A26 motor mount - declared drilling correction

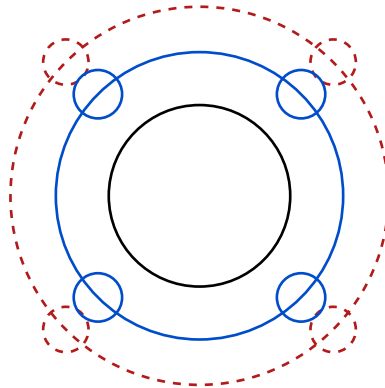
Source: 4x3mm on 25mm PCD. Revised: 4x3.2mm on 19mm PCD.

Red dashed: obsolete 25mm PCD - DO NOT DRILL

Blue: 19mm PCD - four 3.2mm holes

Physical Emax motor check required before drilling; drawing below at 2:1.

Central 12mm hole unchanged. Minimum radial wood web 1.9mm; use washers.
